File #: BC 21-018, **Version:** 1

Certificate of Appropriateness for Proposed Changes to 300 Division St. S. - Jacob Sitze Building.

The Heritage Preservation Commission is asked to review and make a motion on the proposed changes to install an elevated deck on the west side of the building at 300 Division St. S.

NOTES:

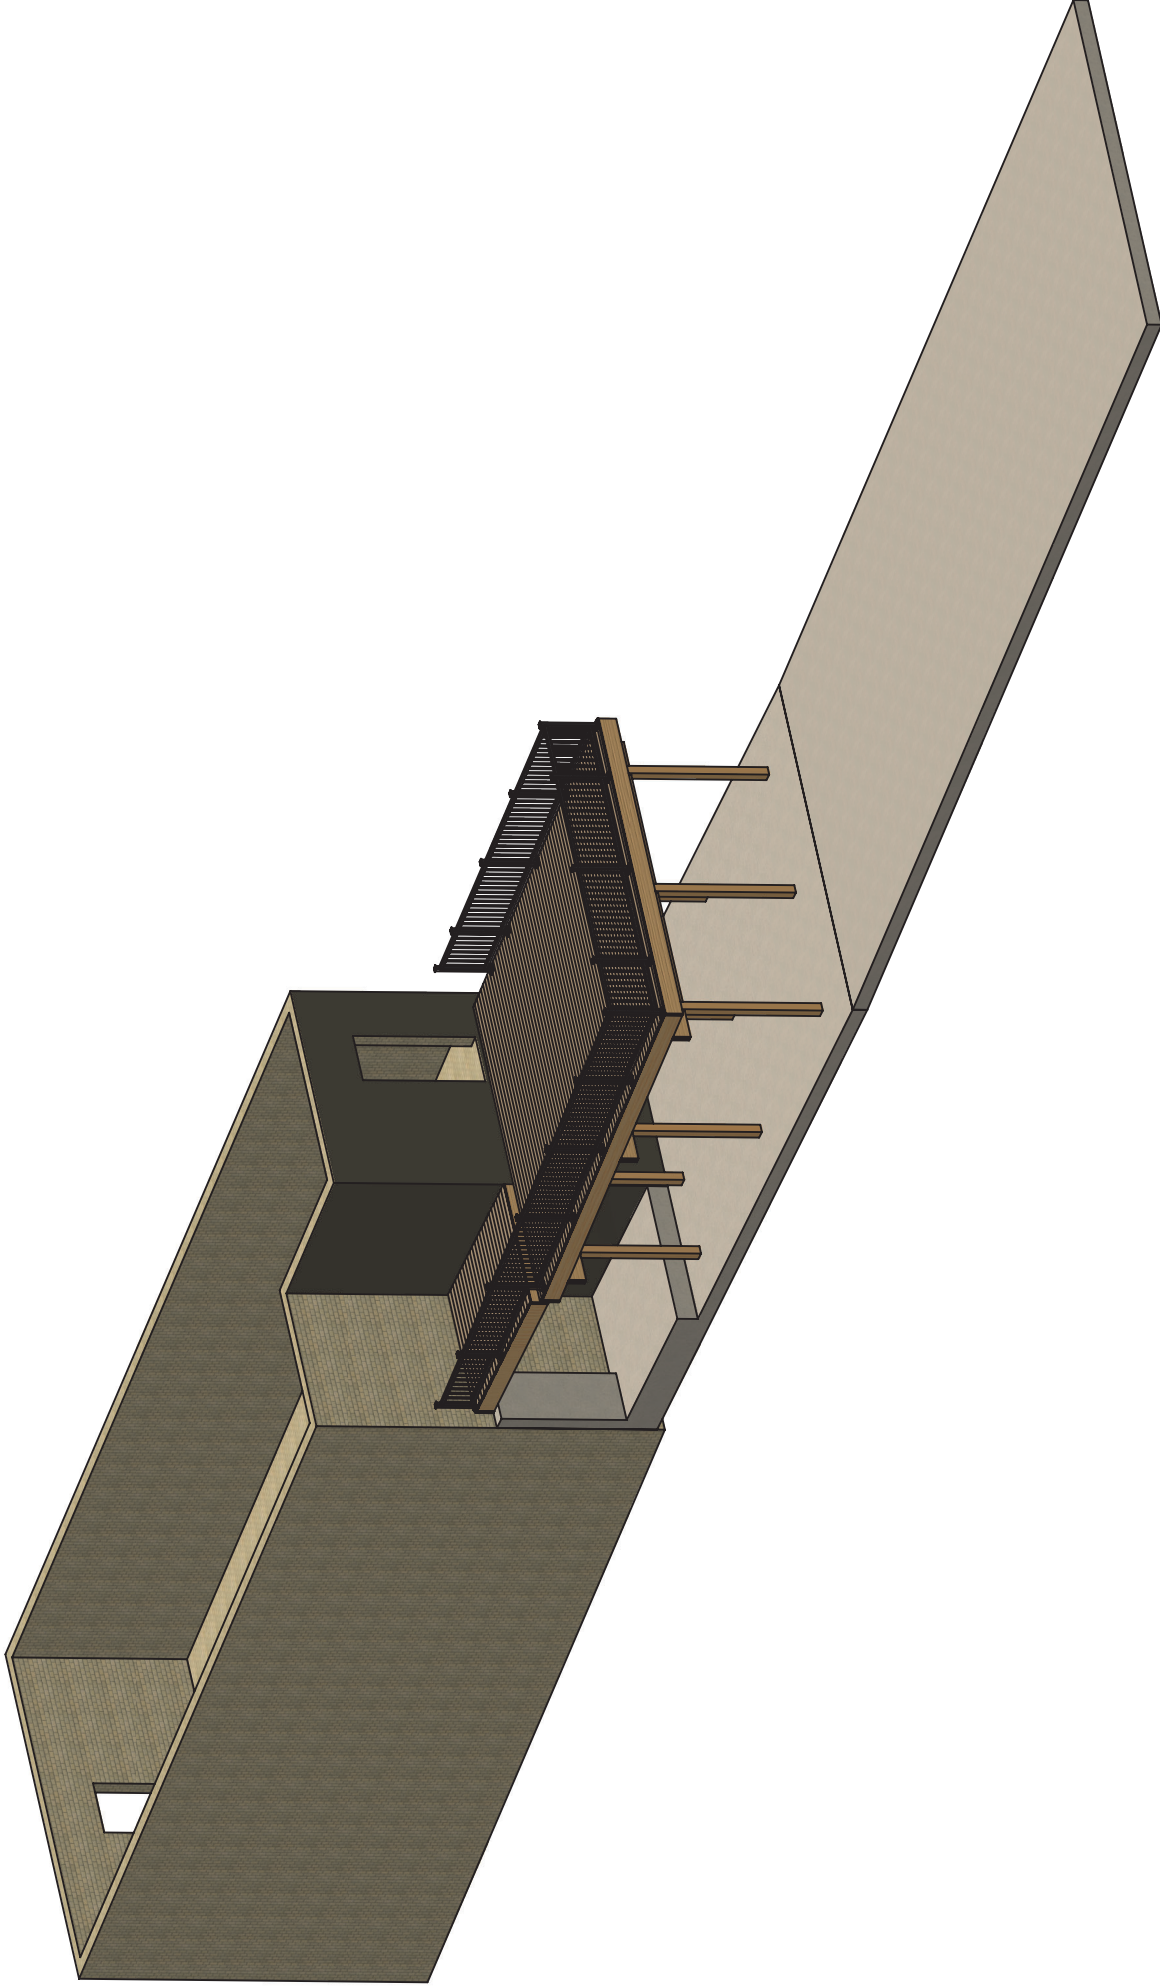
- DECK PREVIOUSLY MODELED AT 22' WIDE = TOTAL LOT WIDTH. THIS HAS BEEN UPDATED TO ~ 20' OVERALL.
- ESTIMATED DISTANCE FROM WALL TO FOOTINGS IS 3' BUT DEPENDENT ON LOCATION OF IN GROUND POWER CURRENTLY USED FOR CONTENTED COW MUSIC STAGE.
- SIZE OF DECK AND LOCATION OF FOOTINGS WILL FLUCTUATE BASED ON ACTUAL ON SITE CIRCUMSTANCES.
- NUANCES OF TIE IN TO CONTENTED COW DECK, AND SMALL DECK NEXT TO LITTLE JOY WINDOW WILL BE DEALT WITH WHEN BUILT AND ARE NOT CURRENTLY MODELED HERE.
- ALL WORK WILL MEET MINNESOTA STATE BUILDING CODE.

Staff recommends approval of the black deck railing, brown composite decking (to match the trusses and framing), stained cedar framing and trusses, location and size of the deck with the ability to modify the proposed deck to include a staircase for ingress and egress per Building Code.
